HISTORIC AND DESIGN REVIEW COMMISSION

February 01, 2017

HDRC CASE NO: 2017-025
ADDRESS: 2018 AVENUE B
LEGAL DESCRIPTION: NCB 6294 (WITTIG OFFICE FURNITURE), LOT 45
ZONING: RIO-1
CITY COUNCIL DIST.: 1
APPLICANT: Jacob Wittig
OWNER: HCIST, LP
TYPE OF WORK: Exterior modifications, window restoration and installation of a new ADA entry
REQUEST:

Renovation/Restoration of the Exterior of 2018 Avenue B

3 NORTH ELEVATION
3/32" = 1'-0"

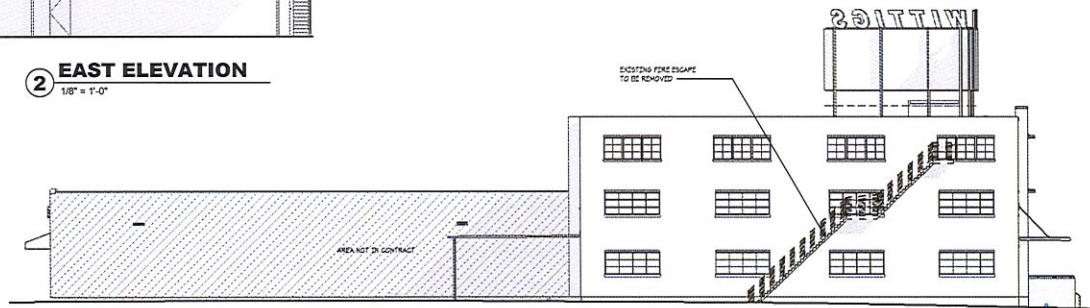
- i. REMOVAL OF FIRE ESCAPE – The applicant has proposed to remove an existing fire escape on the north façade. The fire escape is internal to the site. Staff finds this removal appropriate.

1 SOUTH ELEVATION
1/8" = 1'-0"

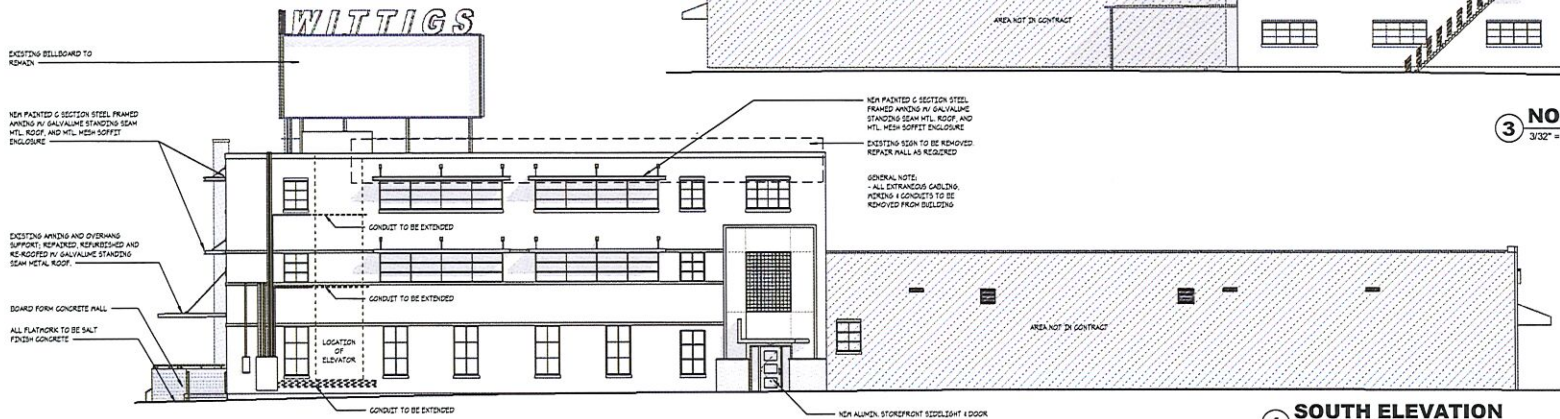
- g. ENTRANCE MODIFICATION – The south façade currently features an entrance in which the applicant has proposed to remove the existing door and install a new ADA compliant door and sidelight. The applicant has noted that the existing opening size will be maintained. Staff finds this appropriate.

- h. REMOVAL OF SIGNAGE – The applicant has proposed to remove the existing cabinet sign on the south elevation and repair the façade beneath. Staff finds this appropriate.
